Item 7.**Development Application: 27 Queen Street, Chippendale****File No.:** D/2018/863**Summary****Date of Submission:** 27 July 2018**Applicant:** The Architecture Company Pty Ltd.**Architect:** John Hepworth**Owner:** Raymond Touma and Paul Touma**Cost of Works:** \$605,000**Zoning:** B4 Mixes Use Zone

Proposal Summary: The proposal involves the construction of two additional apartments at the roof level of an existing three storey residential apartment building. Other works involve the construction of pergolas at the roof level, facade upgrades, new security entry gates and the provision of additional basement level bicycle and apartment storage areas.

Summary Recommendation: This proposal is recommended for refusal.

Figure 10: North elevation plan (as viewed from Queen Street).

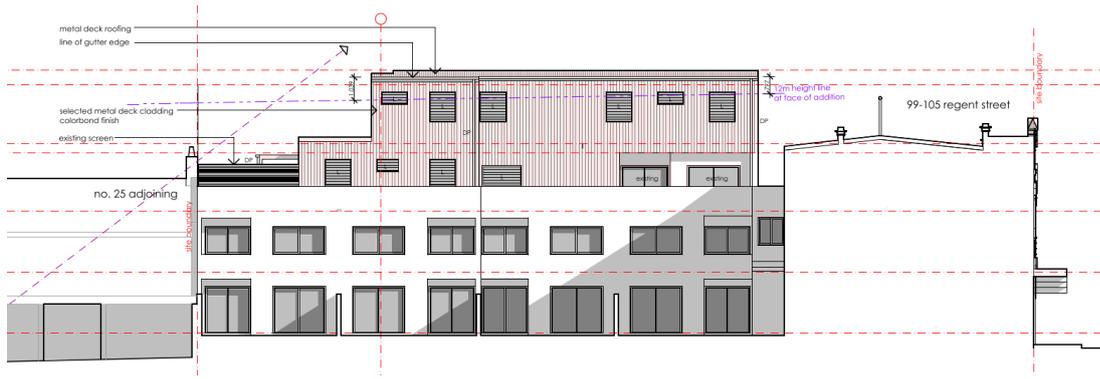
- (b) The proposal does not satisfy the objective of Clause 4.3(1)(b) of SLEP2012, which is to ensure an appropriate height transition between new development and heritage items and buildings in heritage conservation areas on the following basis:
 - (i) the development does not provide an appropriate height transition between the existing 2 storey heritage item within the site, with frontage to Regent Street, and the 2 storey terrace dwellings at 23-25 Queen Street to the west of the site. Instead, the development results in a 4 storey building between 2 storey heritage items (Figure 20 below);

Figure 20: North elevation plan, showing inappropriate height transition between heritage items located within the subject site and to the west of the site at 23-25 Queen Street.

Figure 21: section plan showing 3.1m setback for rear bedroom windows to the southern boundary and a compliant 6m setback as specified by the ADG.

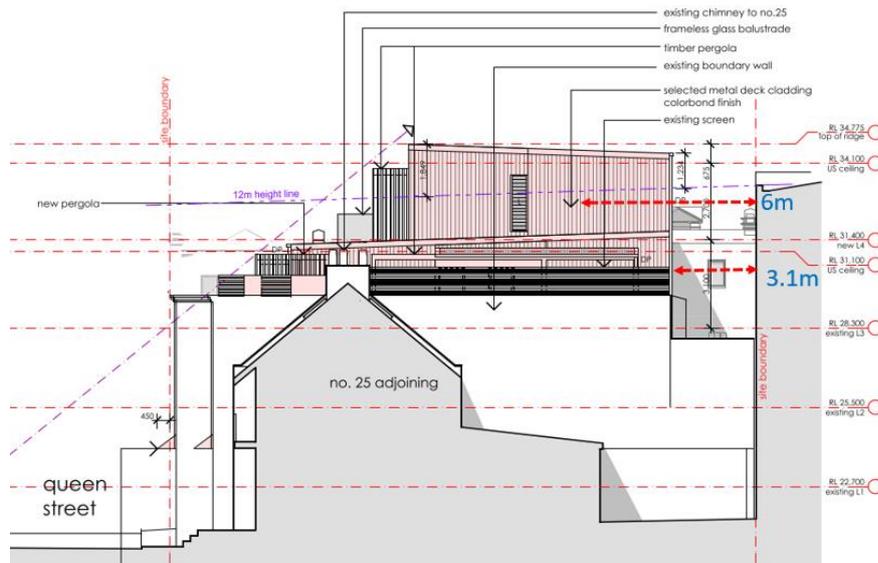
52. The proposed apartments have bedroom windows that are set back 3.1m from the southern boundary (Figure 21 below). As such, the development does not comply with guidance and design criteria provided at Parts 2F and 3F of the ADG that specify the following separation distances between residential apartment buildings and boundaries:

53. By failing to provide the minimum 6m separation, the proposal unreasonably burdens the neighbouring property to the south at 107-109 Regent Street, in the event of a future residential development proposal on the site. Any future residential development at 107-109 Regent Street would be likely to provide windows to living areas and balconies with a northerly aspect which is directly adjacent to the common boundary with the subject site, and would be subject to privacy impacts as a result of the non-compliant setback of the proposed development.

56. On the basis that the applicant has failed to provide acceptable the separation distances between habitable rooms and balconies as required by the ADG, the proposal cannot be supported.
